SUBJECT: Docket 71-9297, Response to Request for Additional Information -
Certificate of Compliance No. USA/9297/AF-96 for Model No. TRAVELLER

Request for Additional Information
for the
Model No. TRAVELLER Package
Docket No. 71-9297

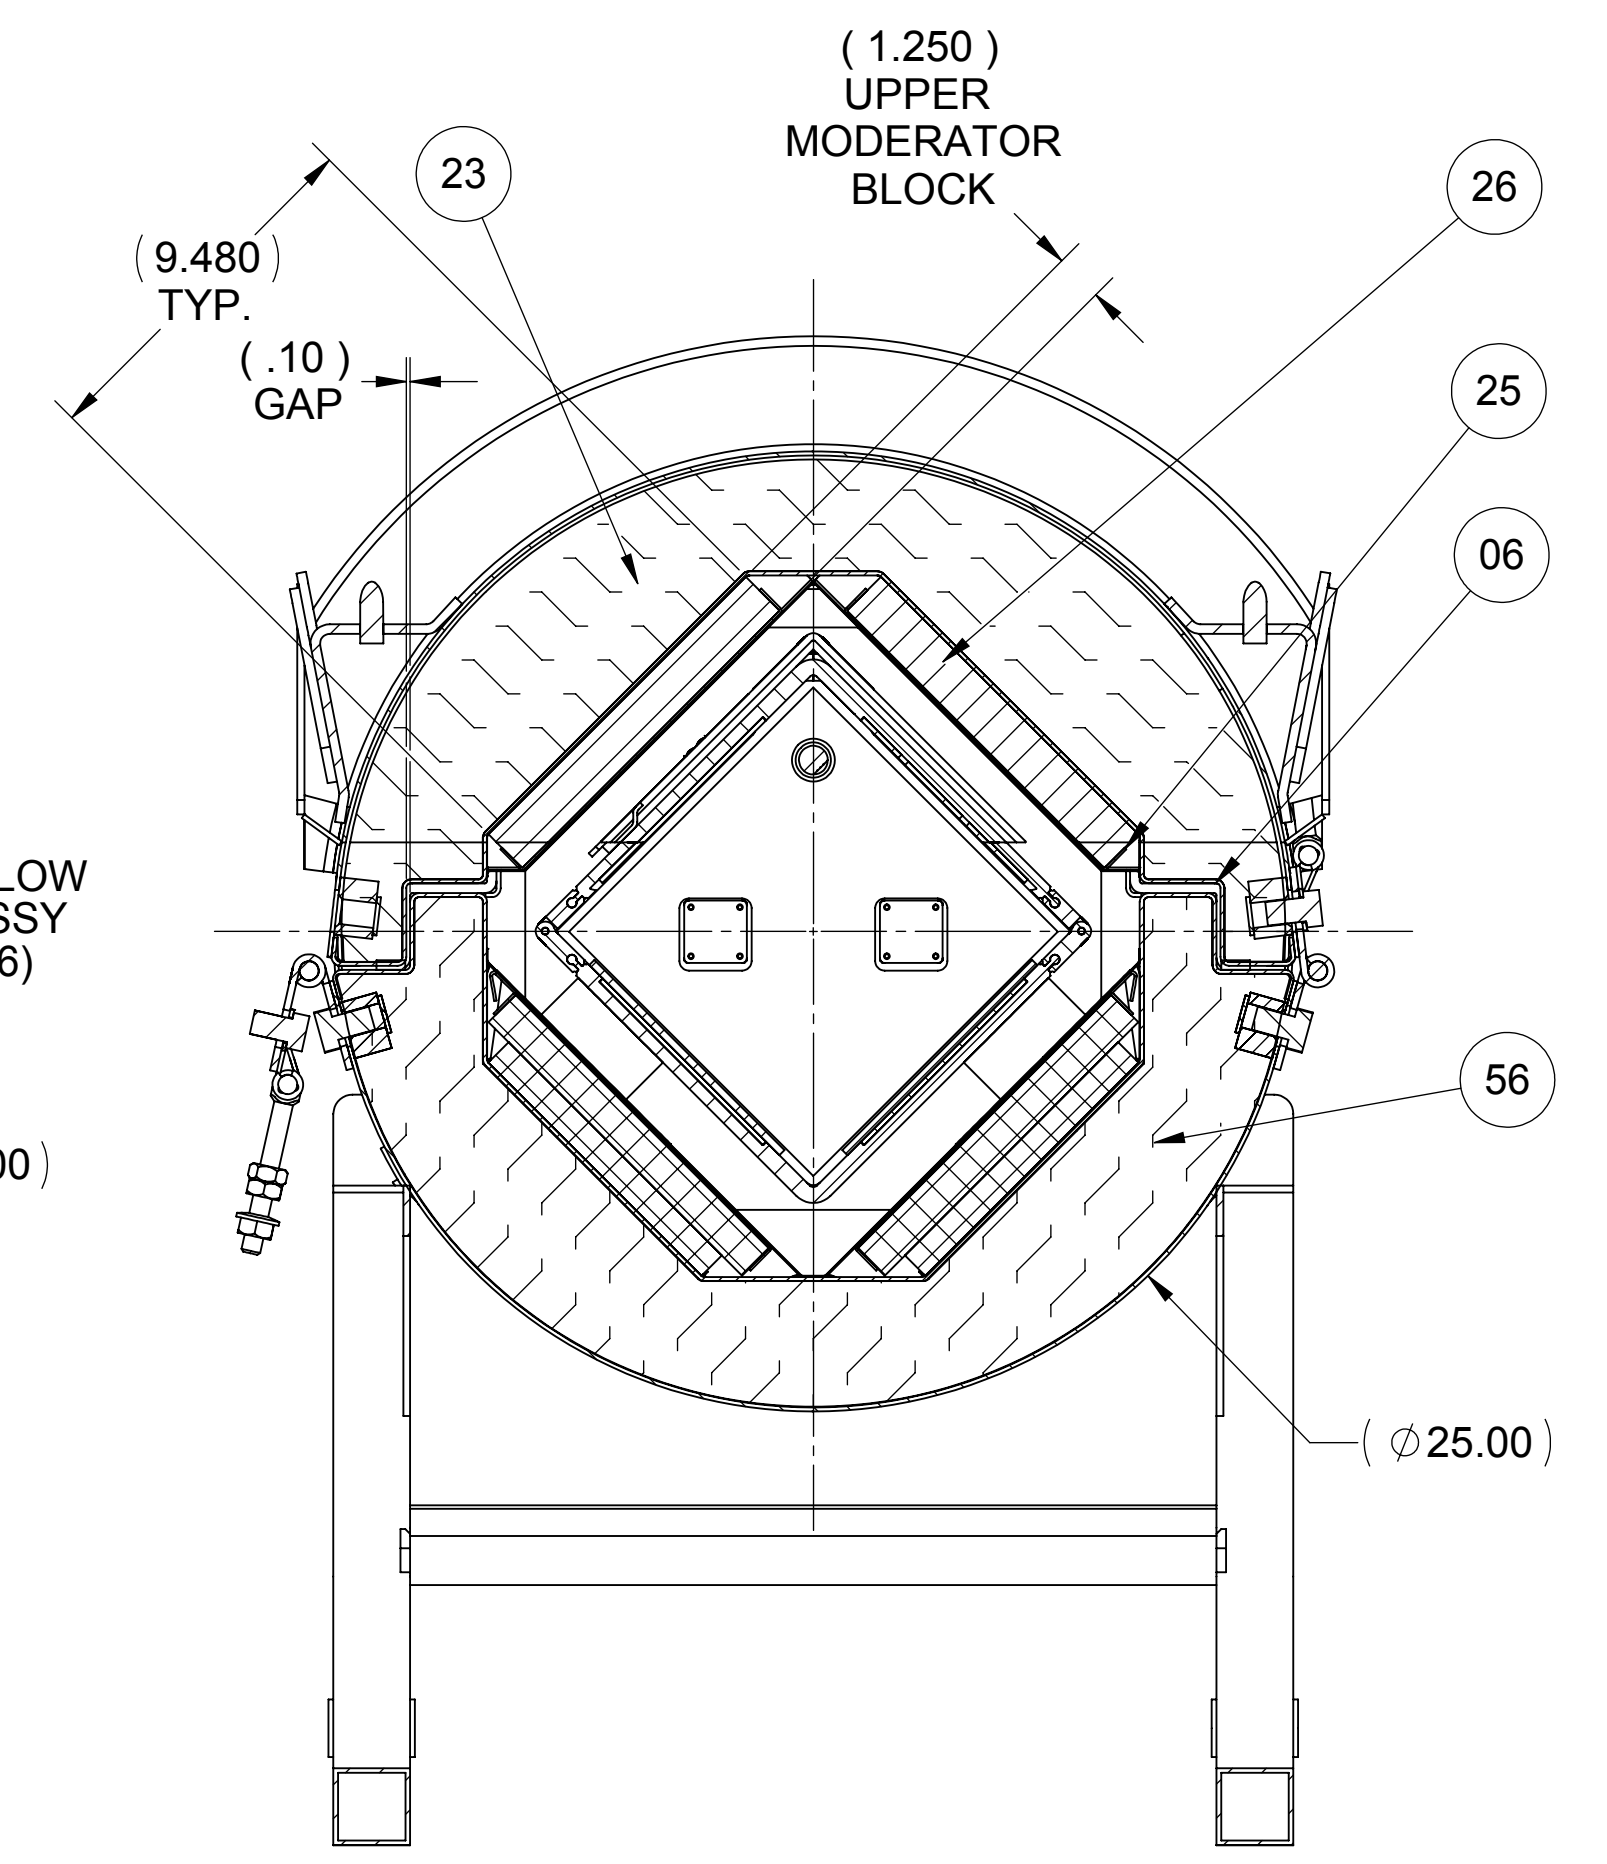
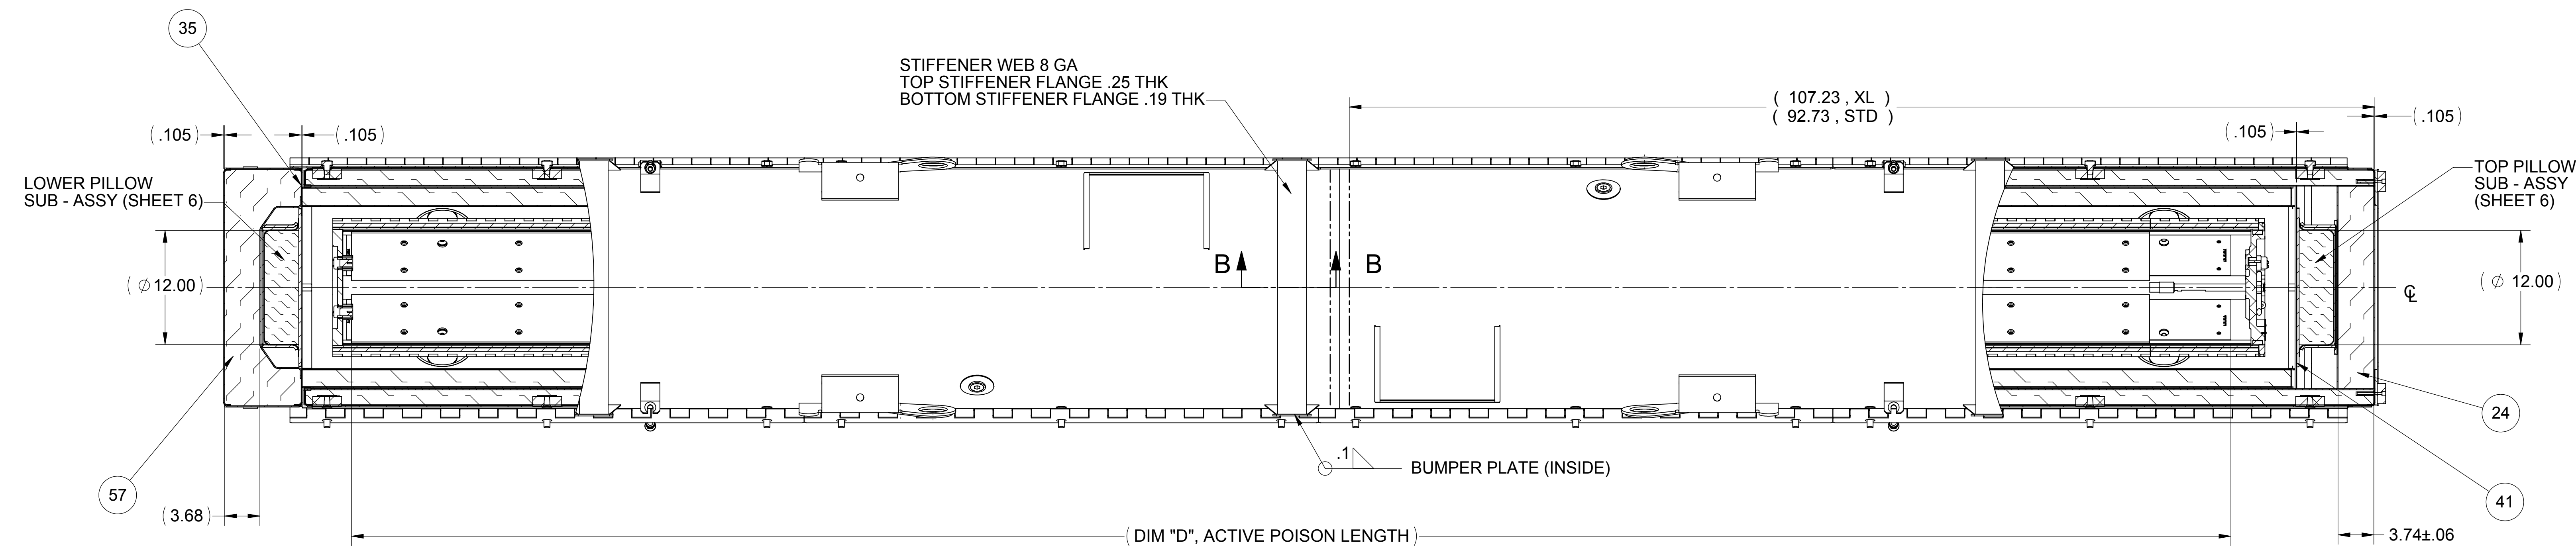
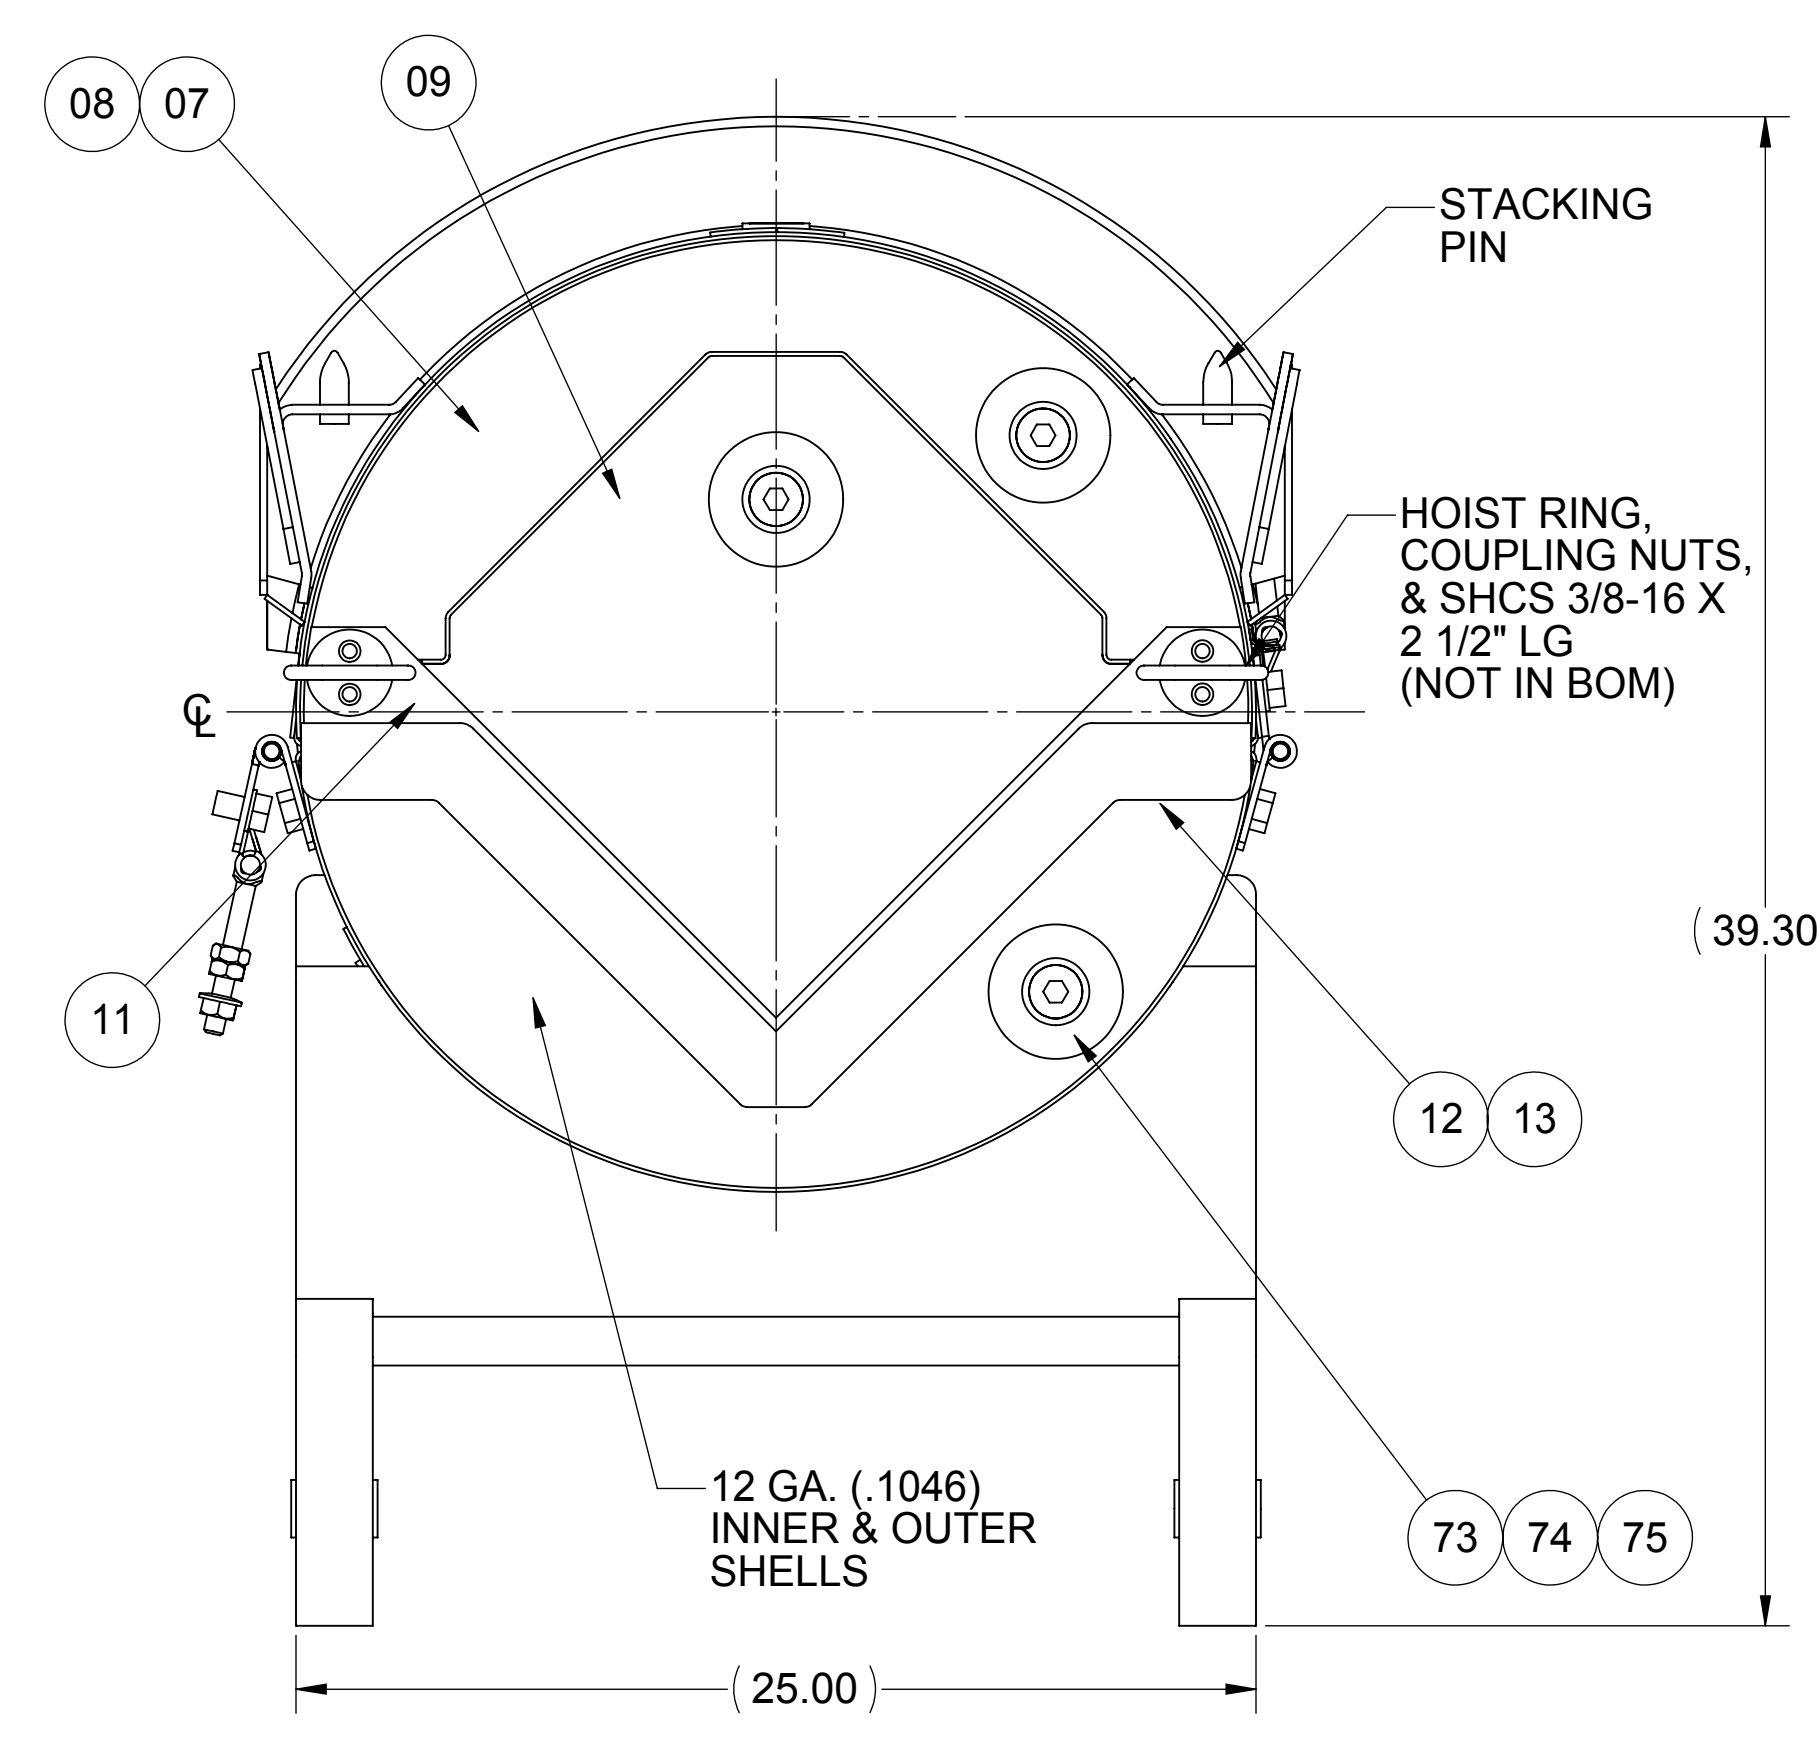
2. Revise DWG 10004E58, Rev. 6 to add sheet numbers to all pages. Staff noted that "Sheet 2 of 9" was missing from the second page of 10004E58, Rev. 6.

Drawing 10004E58, Rev 6. was corrected by adding "Sheet 2 of 9" and is included in another enclosure.
